NOTICE OF PROPOSED CHANGE IN PROPERTY

Petition: x931

DTE Energy
(Utility or City Department)

REQUEST TO OUTRIGHT VACATE
 A PORTION OF BAYSIDE AND DUMFRIES AVE.
 VARIOUS PUBLIC ALLEYS, 20 FT. WD.
 IN THE BLOCKS BOUND BY
 OAKWOOD BLVD., SANDERS, DUNKIRK AVE.
 AND WABASH R.R.

CITY OF DETROIT CITY ENGINEERING DEPARTMENT SURVEY BUREAU	
JOB NO.	01-01
DRWG. NO.	X 931

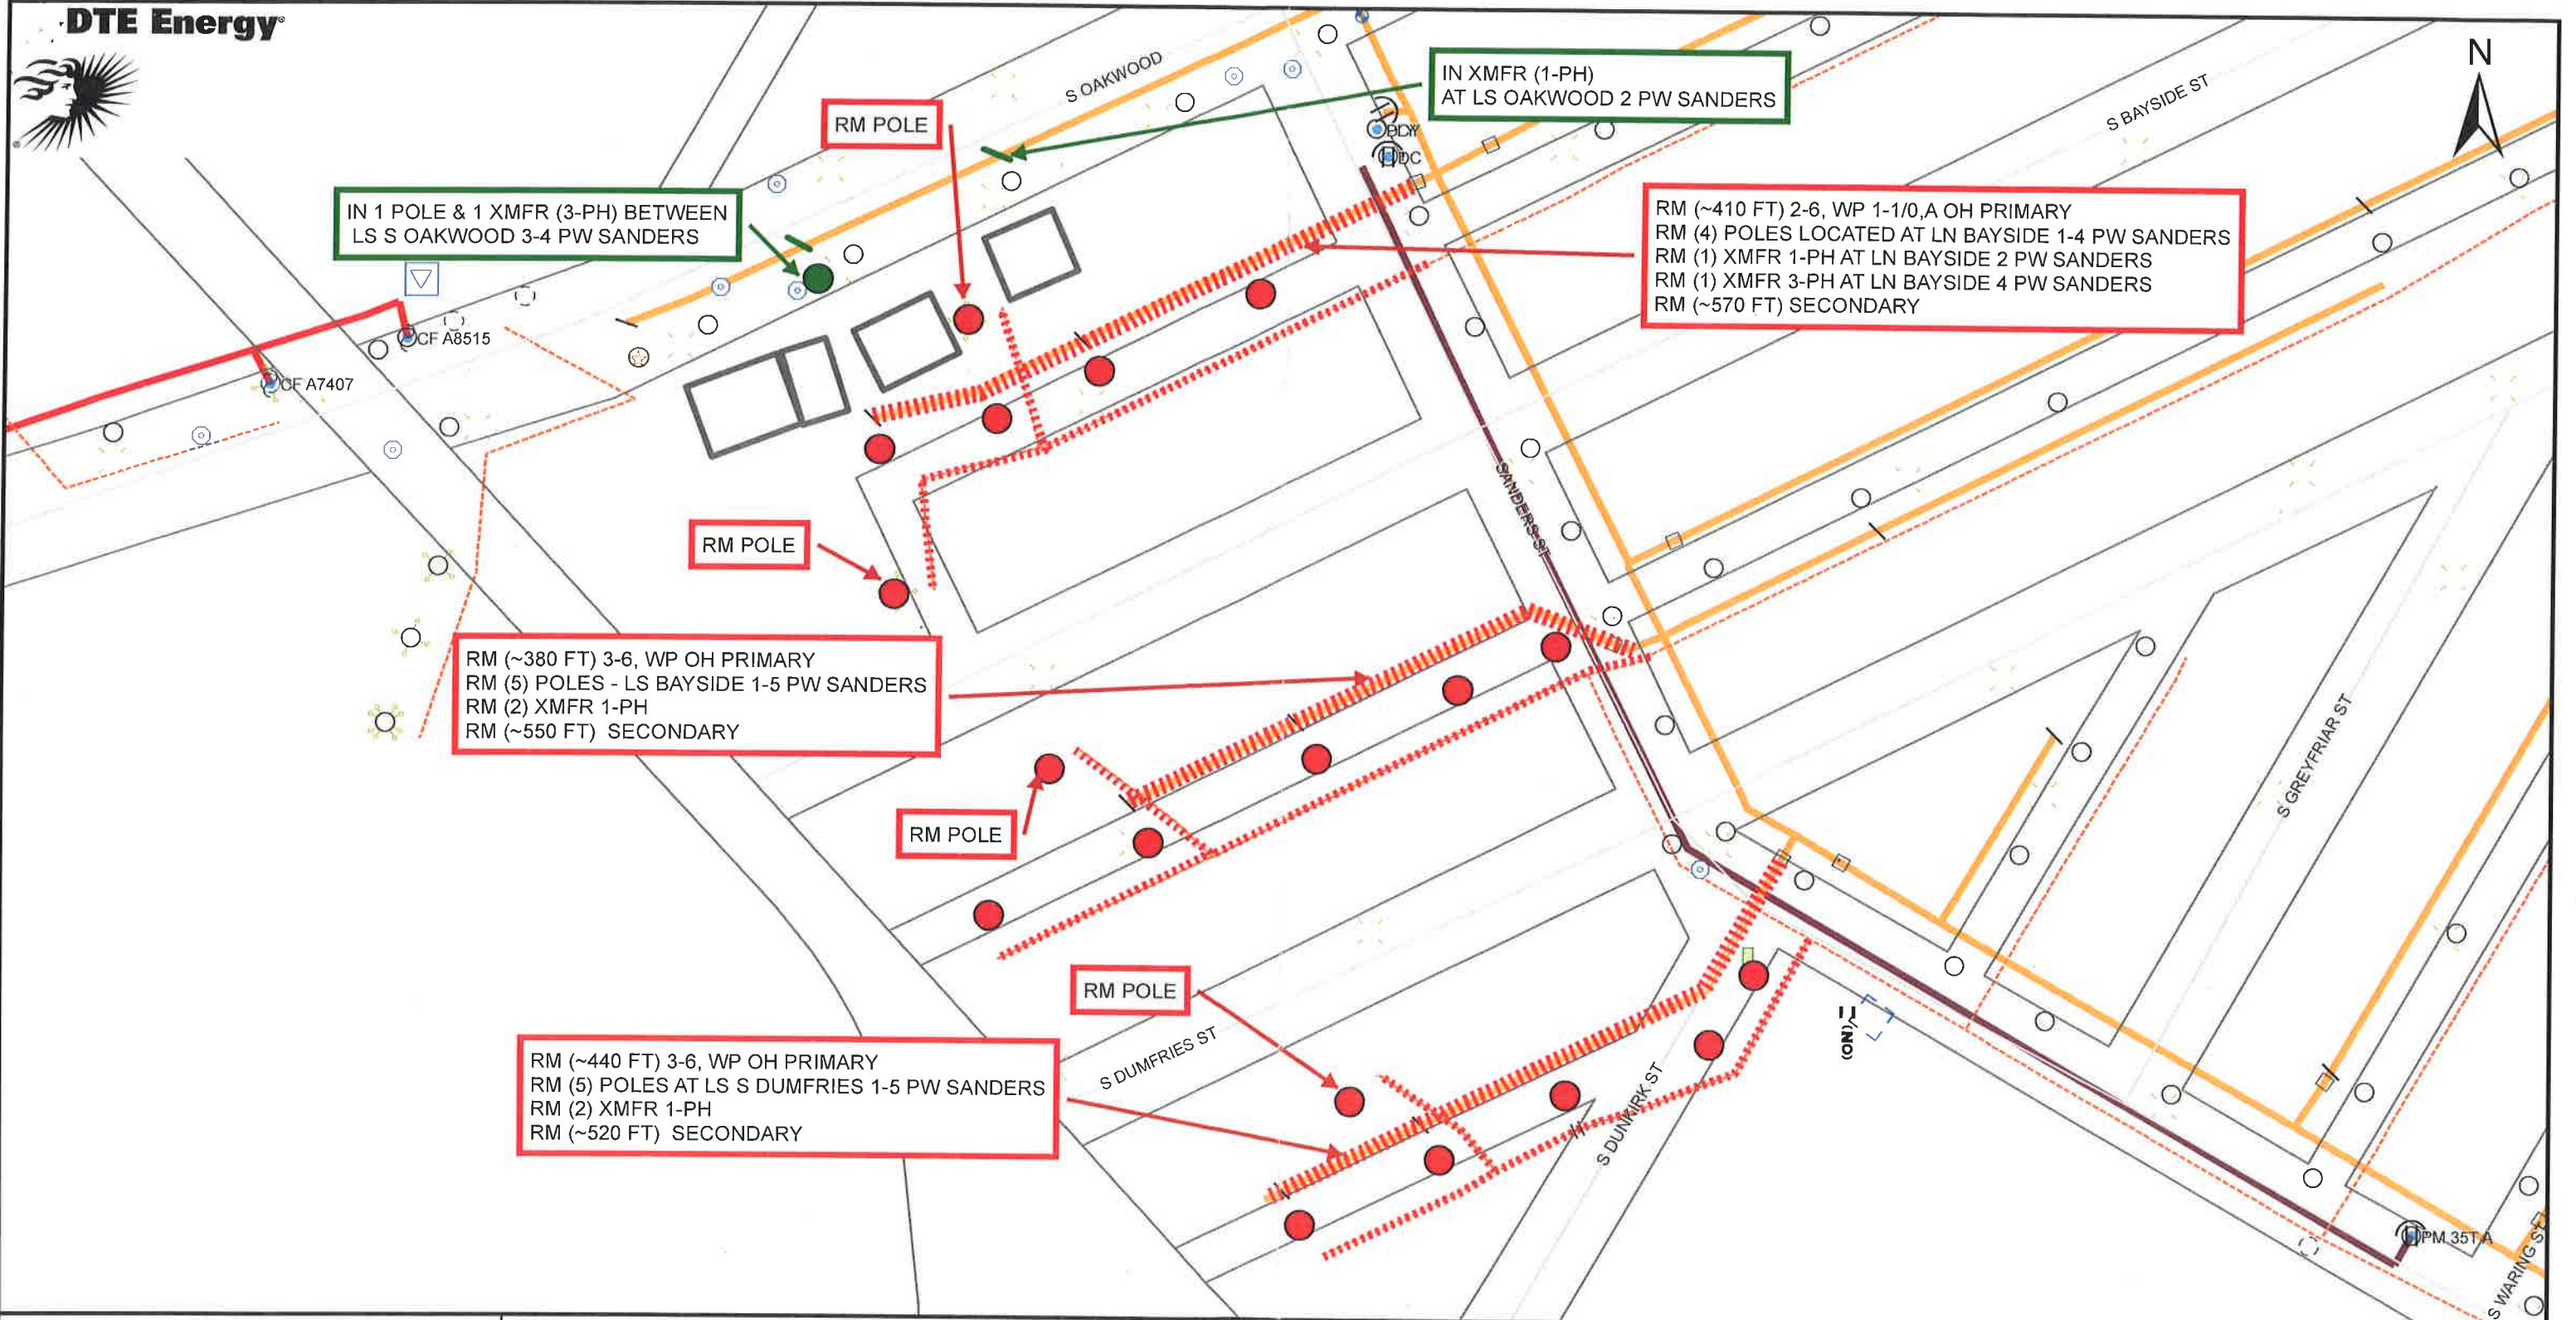
IN 1 POLE & 1 XMFR (3-PH) BETWEEN
LS S OAKWOOD 3-4 PW SANDERS

IN XMFR (1-PH)
AT LS OAKWOOD 2 PW SANDERS

RM (~410 FT) 2-6, WP 1-1/0,A OH PRIMARY
RM (4) POLES LOCATED AT LN BAYSIDE 1-4 PW SANDERS
RM (1) XMFR 1-PH AT LN BAYSIDE 2 PW SANDERS
RM (1) XMFR 3-PH AT LN BAYSIDE 4 PW SANDERS
RM (~570 FT) SECONDARY

RM (~380 FT) 3-6, WP OH PRIMARY
RM (5) POLES - LS BAYSIDE 1-5 PW SANDERS
RM (2) XMFR 1-PH
RM (~550 FT) SECONDARY

RM (~440 FT) 3-6, WP OH PRIMARY
RM (5) POLES AT LS S DUMFRIES 1-5 PW SANDERS
RM (2) XMFR 1-PH
RM (~520 FT) SECONDARY

CONCEPTUAL DESIGN
CIAC COST: \$92,148.98

REASON FOR WORK:
Per customer request to remove DTE equipment located at Detroit Salt Company's property and installing required equipment for service.
